# Access Compliance Report

## Public Rights-of-Way

### (Curb Ramps)

Intersection ID: 24827	Main Street: ARBORETUM_DR	Cross Street: PINEVILLE-MATTHEWS_RD	Location:	N
ADA ID: 7B543FCBD48B	Ramp Type: PerpDiag	Initial Pass/Fail: Fail	Overall Compliance: No	Severity Score: 25

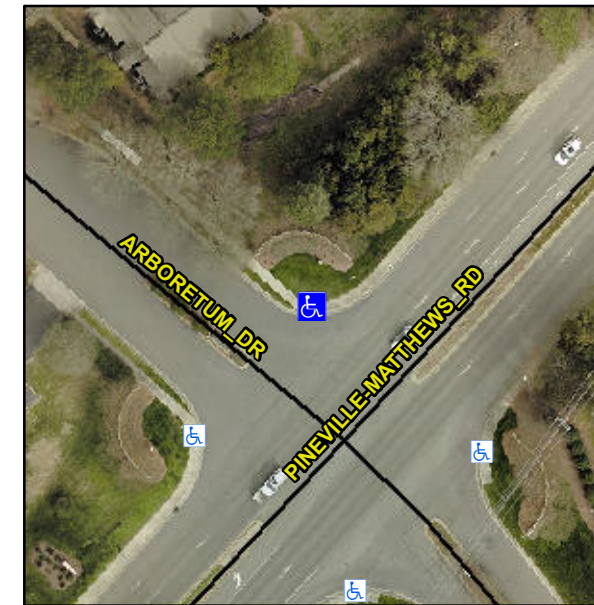
**R304.2.2**

Compliance	Description	Data	Compliance	Description	Data
N/A	Ramp Length (in)	60.0	No	Ramp Slope (%)	12.8
Yes	Ramp Width (in)	48.0	Yes	Ramp XSlope (%)	1.4
N/A	Flare Type LT	N/A	N/A	Flare Type RT	N/A
N/A	Flare Slope LT (%)	N/A	N/A	Flare Slope RT (%)	N/A
N/A	Flare Traversable LT?	N/A	N/A	Flare Traversable RT?	N/A
N/A	Landing Length (in)	N/A	N/A	DWS Provided?	N/A
N/A	Landing Width (in)	N/A	N/A	DWS Contrast?	N/A
N/A	Landing Slope (%)	N/A	N/A	DWS Length (in)	N/A
N/A	Landing X Slope (%)	N/A	N/A	DWS Full Width?	N/A
N/A	Landing Curb? (Y/N)	N/A	N/A	DWS Offset (in)	N/A
N/A	Shared Landing?	N/A			
N/A	Gutter Ponding?	N/A	N/A	Gutter Slope (%)	N/A
N/A	Gutter Lip Ht (in)	N/A	N/A	Gutter X Slope (%)	N/A
N/A	Painted X Walk1?	No	N/A	Painted X Walk2?	No
	X Walk 1 Direction	To SW		X Walk 2 Direction	To SE
N/A	X Walk 1 Width (in)	N/A	N/A	X Walk 2 Width (in)	N/A
	X Walk 1 Slope (%)	3.0		X Walk 2 Slope (%)	0.4
	X Walk 1 X Slope (%)	0.3		X Walk 2 X Slope (%)	1.8

**Remove & Replace Curb Ramp With Two New Directional Ramps or Equivalent.**
